DELEGATED OFFICER REPORT

WOKINGHAM
BOROUGH COUNCIL

Application Number:	252573
Site Address:	The Poppies, Waterloo Road, Wokingham, RG40 2JU
Expiry Date:	27 November 2025
Proposal: Application for non-material amendment to planning consent 232002 for changes to fenestration and the position of the external staircase, addition of a Juliet balcony and external first floor cladding, modification of roof design and changes to the number and position of the rooflights.

Figure 1: Approved plans from application 232002

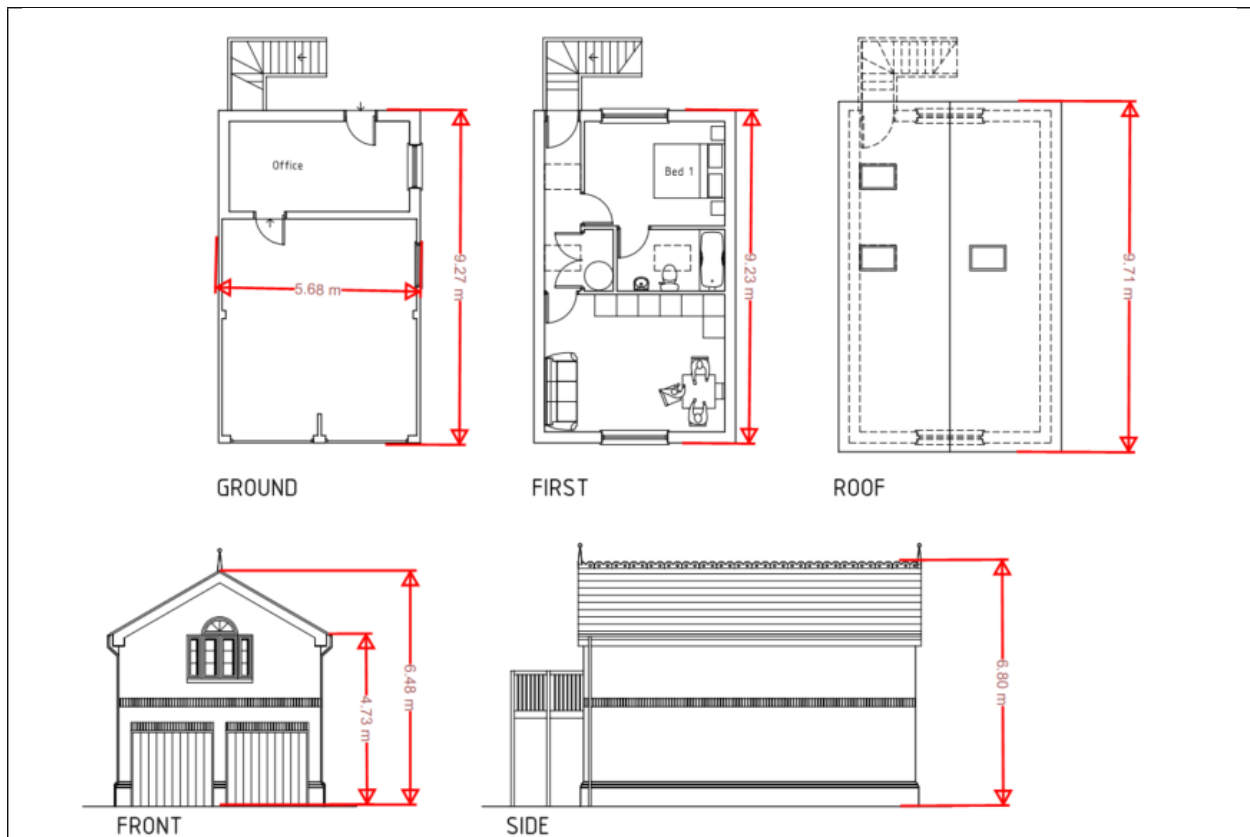
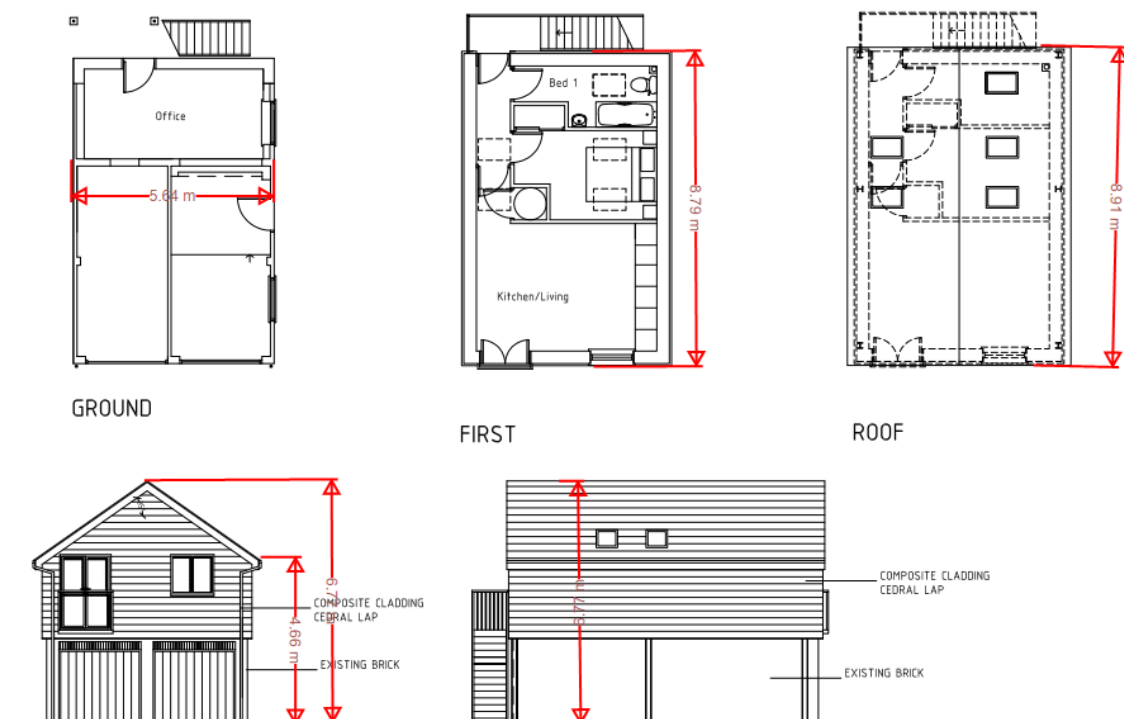
As seen in figures 1 and 2 above, the length of the garage is being reduced by approximately 0.4 metres. The reduction in the size of the garage would not

significantly alter the external appearance of the garage, and therefore the reduction in size is deemed as being a non-material change.
